# Access Compliance Report

## Public Rights-of-Way

Intersection ID: 44540	Main Street: NEAL_RD	Cross Street: UNIVERSITY_CITY_BV	Location: E
ADA ID: E40E621C233D	Ramp Type: Perp	Initial Pass/Fail: Fail	Overall Compliance: No
Severity Score: 21.25			
Codes/Mitigation Info/Possible Solution		Field Measurements/Component Compliance

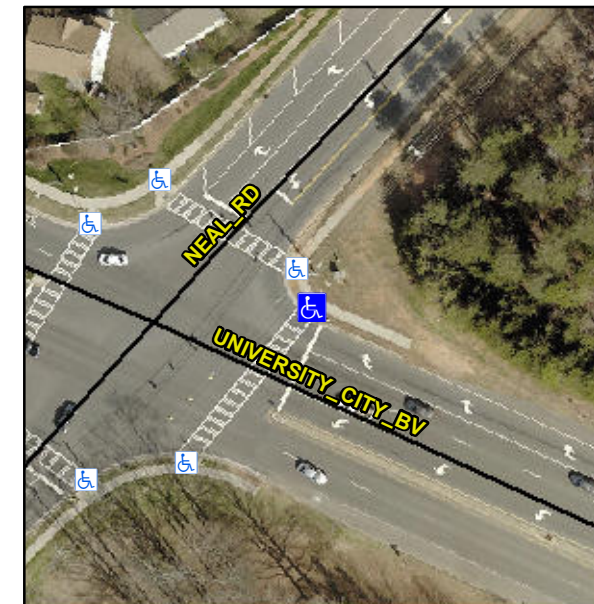
**Remove & Replace Entire Ramp.**

**Not Found, R304.5.1, R304.2.2**

Compliance	Description	Data	Compliance	Description	Data
N/A	Ramp Length (in)	55.0	No	Ramp Slope (%)	8.5
No	Ramp Width (in)	47.0	Yes	Ramp XSlope (%)	1.7
N/A	Flare Type LT	N/A	N/A	Flare Type RT	N/A
N/A	Flare Slope LT (%)	N/A	N/A	Flare Slope RT (%)	N/A
N/A	Flare Traversable LT?	N/A	N/A	Flare Traversable RT?	N/A
N/A	Landing Length (in)	N/A	N/A	DWS Provided?	N/A
N/A	Landing Width (in)	N/A	N/A	DWS Contrast?	N/A
N/A	Landing Slope (%)	N/A	N/A	DWS Length (in)	N/A
N/A	Landing X Slope (%)	N/A	N/A	DWS Full Width?	N/A
N/A	Landing Curb? (Y/N)	N/A	N/A	DWS Offset (in)	N/A
N/A	Shared Landing?	N/A			
N/A	Gutter Ponding?	Yes	N/A	Gutter Slope (%)	N/A
N/A	Gutter Lip Ht (in)	N/A	N/A	Gutter X Slope (%)	N/A
N/A	Painted X Walk1?	Yes	N/A	Painted X Walk2?	N/A
	X Walk 1 Direction	To SW		X Walk 2 Direction	N/A
N/A	X Walk 1 Width (in)	103.0	N/A	X Walk 2 Width (in)	N/A
	X Walk 1 Slope (%)	3.4		X Walk 2 Slope (%)	N/A
	X Walk 1 X Slope (%)	0.3		X Walk 2 X Slope (%)	N/A
